MOTORCYCLE PARTS NEWS

TX650, TX650A and XS Series

BRONZE SWING ARM BUSHINGS

NUMBER
398A
PAGE
1 of 1

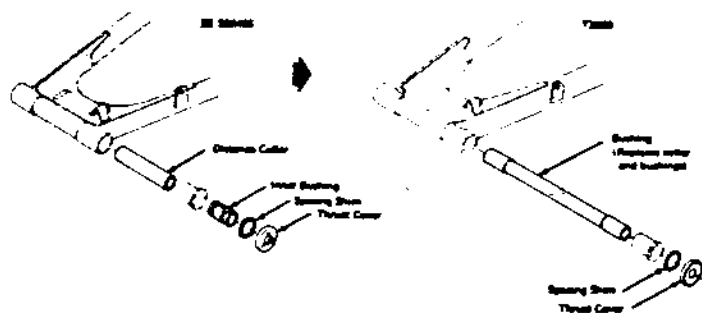
The part number for the bronze swing arm bushing shown in Motorcycle Parts News Bulletin No. 321 has been changed.

The bronze bushing is an accessory item and is not used in production. They can be installed on any XS1, XS1B, XS2, TX650 or TX650A to minimize swing arm free play.

NOTE: When installing bronze bushings on XS1's, XS1B's and XS2's, the inner bushings, the distance collar and the thrust covers must be replaced with TX650 parts.

OLD P/N	NEW P/N	DESCRIPTION	QTY.	PRICE DISC.
258-22123-00-00	ACC-1111B-41-00	BUSHING, rear arm	2

CAUTION: Always check swing arm side play and add or remove spacing shims (P/N 240-22127-00-00) to allow .005 in. side play. See Motorcycle Parts News Bulletin No. 262 for measurement procedure.

BATTERY BOX MODIFICATION

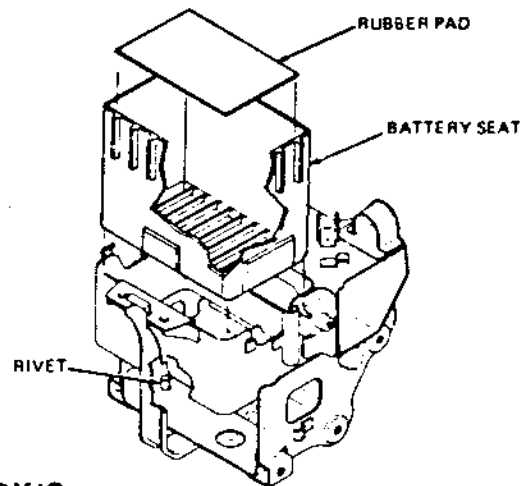
On TX650A's, E/N ~ 447-006760, the rivet holding a bracket to the bottom of the battery box (right side) is too long. The long rivet may cause damage to the battery.

A rubber pad is now available which will prevent possible damage to the battery. The part number is 908-91200-01-00. Install protective pad between rubber battery seat and battery. See drawing below.

1. TX650A, E/N ~ 447-006760 needs pad.
2. Factory has installed shorter rivet on E/N 447-006761 ~.
